Access Compliance Report

Public Rights-of-Way

(Curb Ramps)

Intersection ID: 2658	Main Street: CRESTWICK_CT	Cross Street: FAIRVISTA_DR	Location: SE
ADA ID: E8CD6D7D50C0	Ramp Type: Perp	Initial Pass/Fail: Fail	Overall Compliance: No
		Severity Score: 12.5

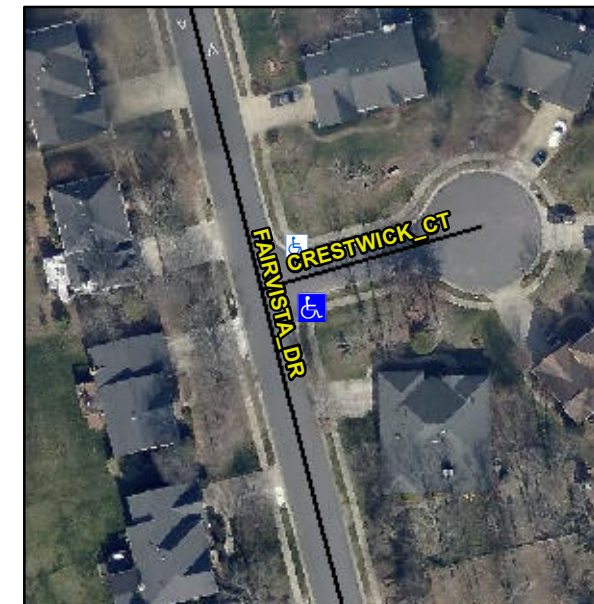
Not Found, R304.2.2

Compliance	Description	Data	Compliance	Description	Data
N/A	Ramp Length (in)	48.0	No	Ramp Slope (%)	11.1
Yes	Ramp Width (in)	48.0	Yes	Ramp XSlope (%)	2.0
N/A	Flare Type LT	N/A	N/A	Flare Type RT	N/A
N/A	Flare Slope LT (%)	N/A	N/A	Flare Slope RT (%)	N/A
N/A	Flare Traversable LT?	N/A	N/A	Flare Traversable RT?	N/A
N/A	Landing Length (in)	N/A	N/A	DWS Provided?	N/A
N/A	Landing Width (in)	N/A	N/A	DWS Contrast?	N/A
N/A	Landing Slope (%)	N/A	N/A	DWS Length (in)	N/A
N/A	Landing X Slope (%)	N/A	N/A	DWS Full Width?	N/A
N/A	Landing Curb? (Y/N)	N/A	N/A	DWS Offset (in)	N/A
N/A	Shared Landing?	N/A			
N/A	Gutter Ponding?	N/A	N/A	Gutter Slope (%)	N/A
N/A	Gutter Lip Ht (in)	N/A	N/A	Gutter X Slope (%)	N/A
N/A	Painted X Walk1?	No	N/A	Painted X Walk2?	N/A
	X Walk 1 Direction	To N		X Walk 2 Direction	N/A
N/A	X Walk 1 Width (in)	N/A	N/A	X Walk 2 Width (in)	N/A
	X Walk 1 Slope (%)	0.1		X Walk 2 Slope (%)	N/A
	X Walk 1 X Slope (%)	2.4		X Walk 2 X Slope (%)	N/A

Remove & Replace Entire Ramp.
